24-C-1
211 Marginal Way
Bayside East
Tranum & Co.

**CITY OF PORTLAND, MAINE
DEVELOPMENT REVIEW APPLICATION
PLANNING DEPARTMENT PROCESSING FORM**

Re: Bayside East, 211 Marginal Way, Portland, Maine (formerly Strictly Formal)

Re: Bayside East, 211 Marginal Way, Portland, Maine

LIGHTING LAYOUT IN FOOT CANYONS

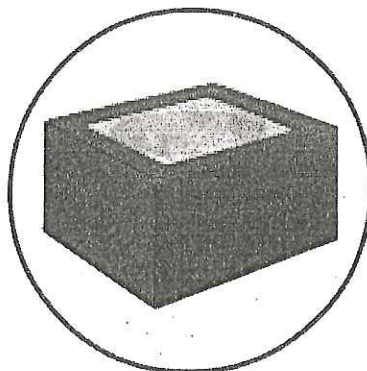
doesn't show all
the fixtures

2. A curb or guard rail is needed along AAA side of the parking lot to make cars stay on the site.
3. Please make sure the site plan notes reference the correct light fixture specs were submitted. Not all the light fixtures were shown on the photometrics. I'm not finished with review of the photometrics.
